Test Mass Discharging System (TMDS) *Design Review*

20 Nov 2014

Proposed Test Mass Discharging System (TMDS)

Pending Corrections

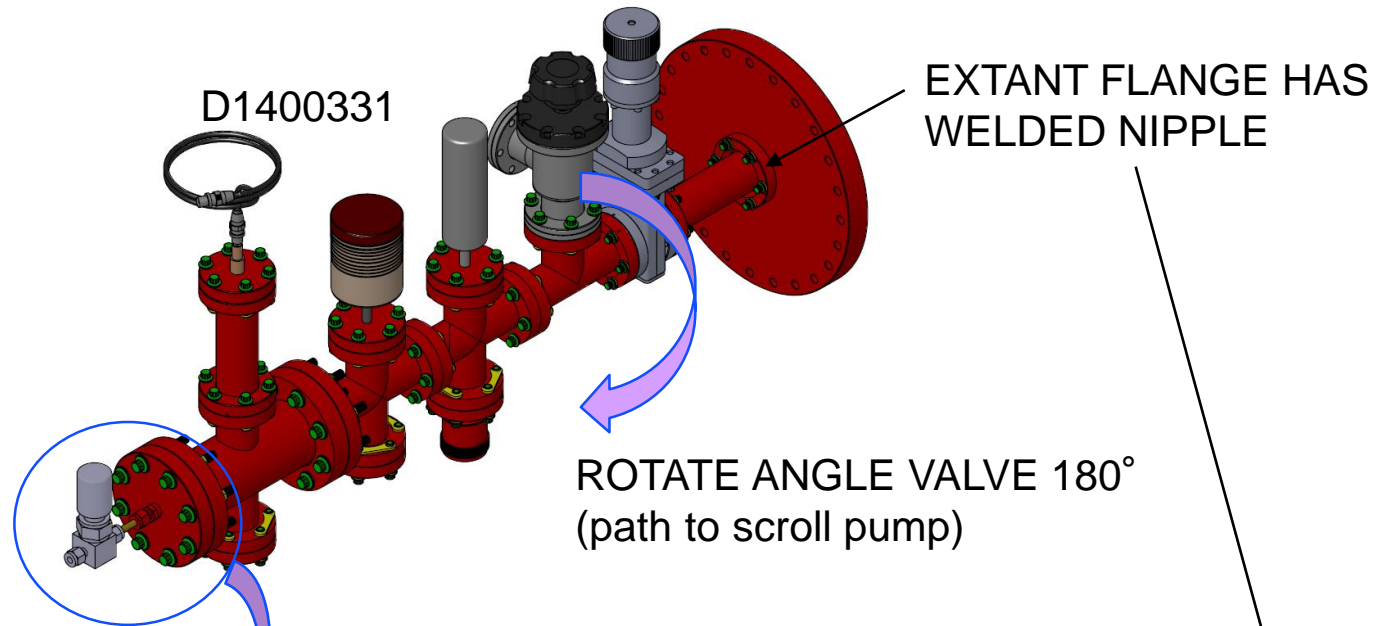
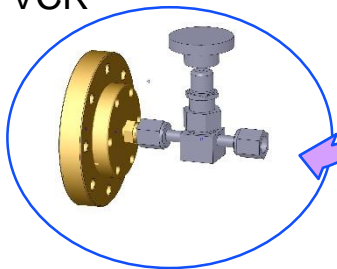
FOR EASIER LEAK CHECKING: CHANGE FROM PIPE THREAD TO SWAGELOK FITTING TO ZERO-LENGTH CF FITTING TO VCR

Pending Corrections

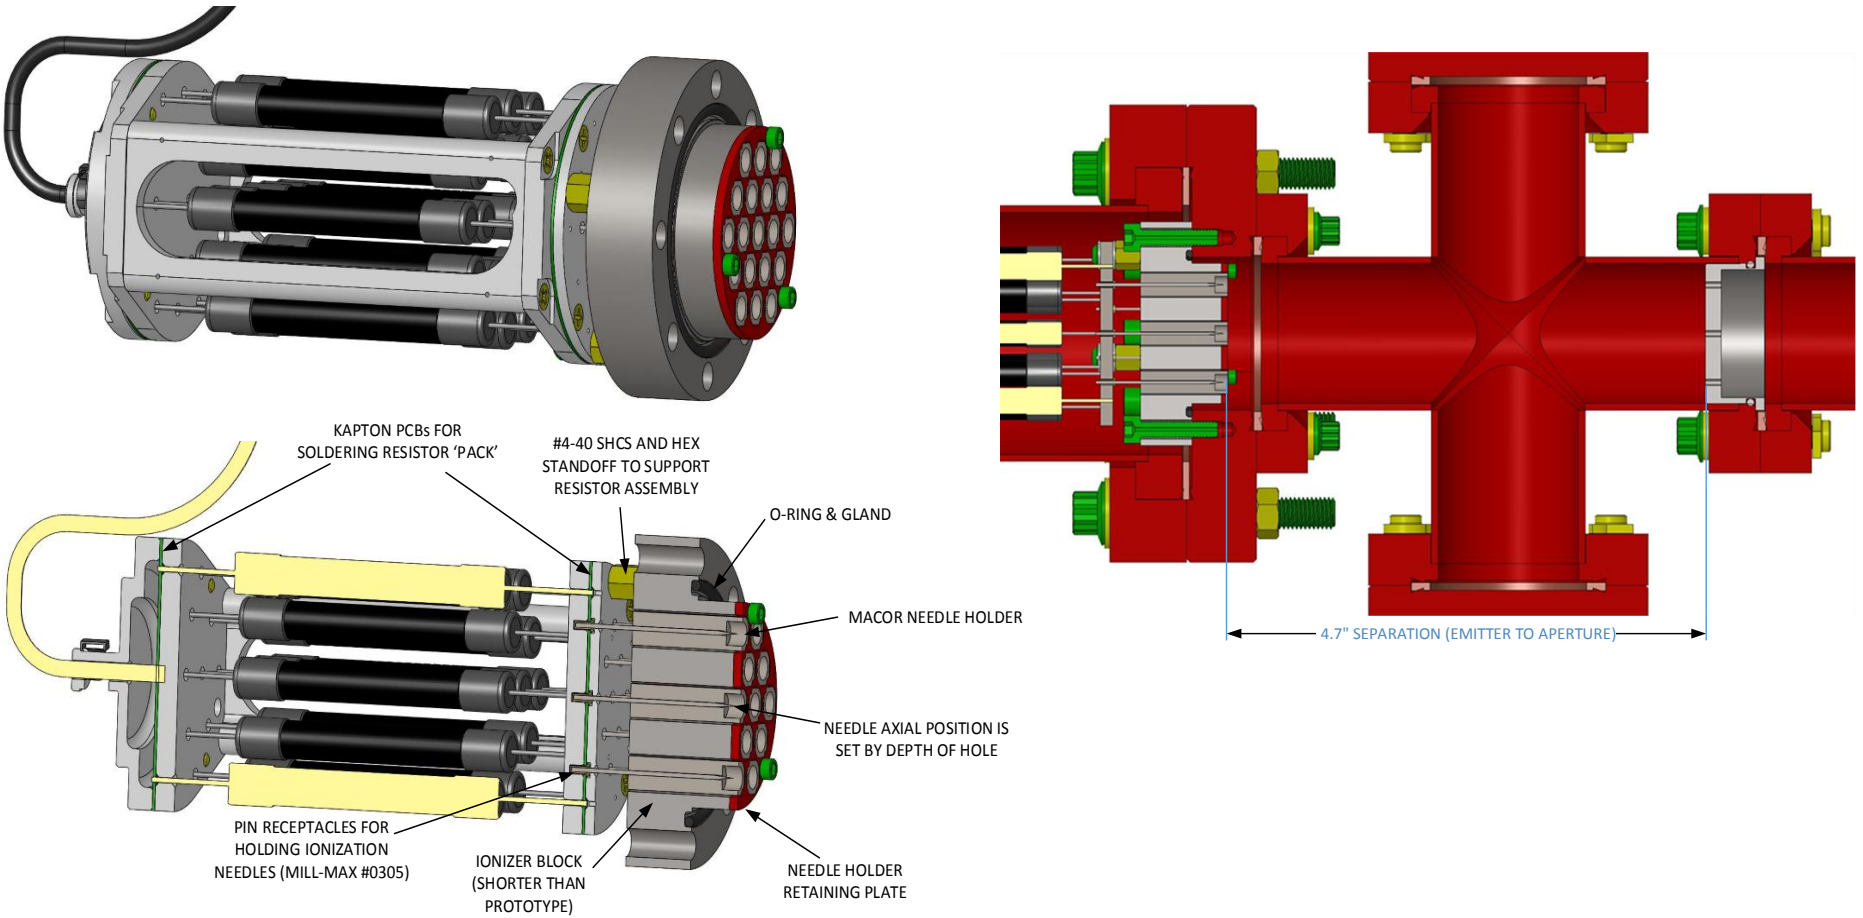
- Incorporate alignment marks/references to facilitate alignment of the emitter array to the aperture plate holes
